VOLUME 4: APPENDIX V1-4.3: SCOPING OPINION – JUNE 2024

**Scoping Opinion on behalf of Scottish Ministers
under the Electricity Works (Environmental Impact
Assessment) (Scotland) Regulations 2017**

Strathy South Wind Farm Grid Connection

Scottish Hydro Electric Transmission Plc

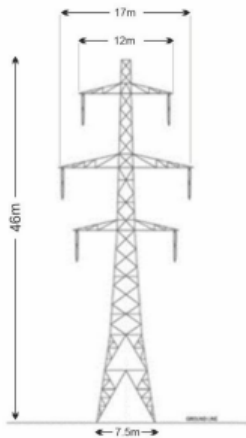
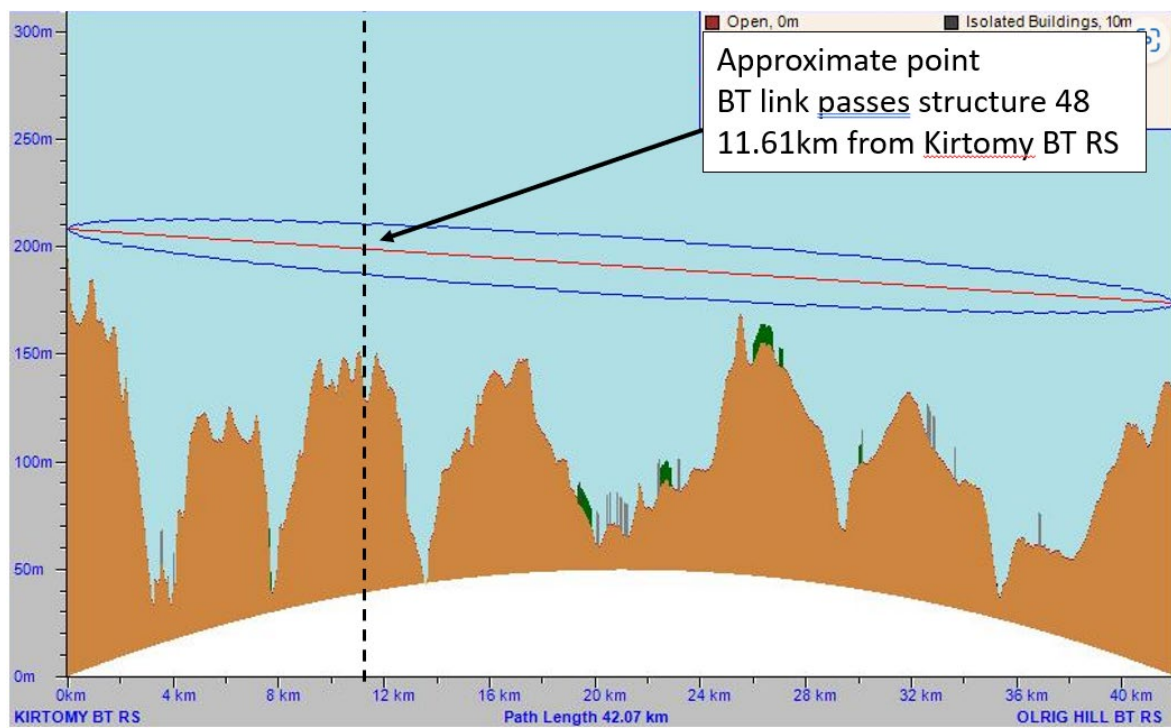
However, structure 48, grid-ref 287210/964242 will be 60m from a BT fixed link.

Taking into account the L8 lattice tower has an arm of 17m, then 8.5m would further reduce the buffer zone, leaving 51.5m

The ground altitude at structure 48 is 102m + 46m tower height = 148m

BT's fixed link passes above this height.

If the proposed grid-ref's do change at all, please inform us so we can re-assess
